CITY OF WARWICK, RHODE ISLAND WARWICK SEWER AUTHORITY STORAGE BUILDING - CONTRACT 104 ADDENDUM NO. 1

February 2, 2022

The following information is provided as part of the Contract Documents as Addendum No. 1.

BUILDING PLAN
SCALE: 1/8"=1'-0"

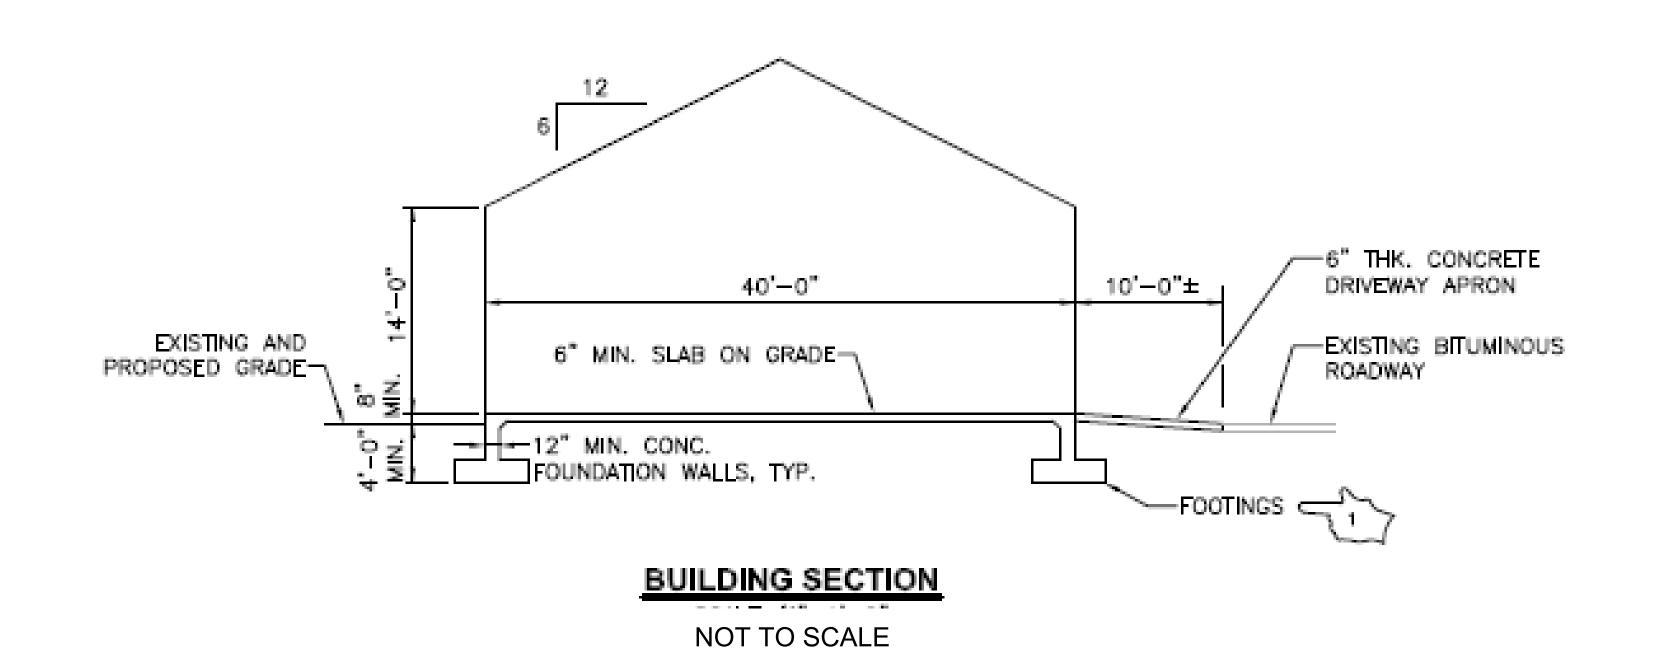
- 6. Delete Plan Sheet "Proposed Storage Building and replace with the attached Addendum Sheet. The drawing has been changed to indicate a foundation footing.
